MIL-R-83536/2
AMENDMENT 3
21 August 1998
SUPERSEDING
AMENDMENT 2
30 September 1996

MILITARY SPECIFICATION SHEET

RELAYS, ELECTROMAGNETIC, ESTABLISHED RELIABILITY, DPDT, LOW LEVEL TO 5 AMPERES, PERMANENT MAGNET DRIVE, HERMETICALLY SEALED, ALL WELDED, TRANSIENT SUPPRESSED DC COILS

CIRCUIT DIAGRAM (NO MOUNT, RVFM, HFH AND TRACK MOUNT A)
(OPTIONAL INTERNAL
DIODE CONFIGURATION)

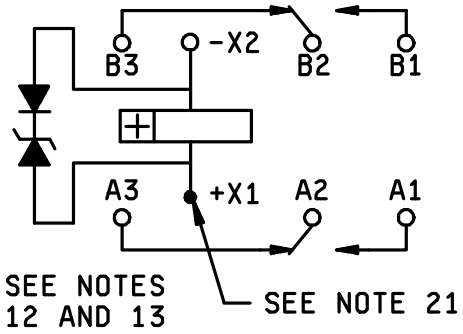
FIGURE 1, add the following circuit diagram between the existing diagrams:
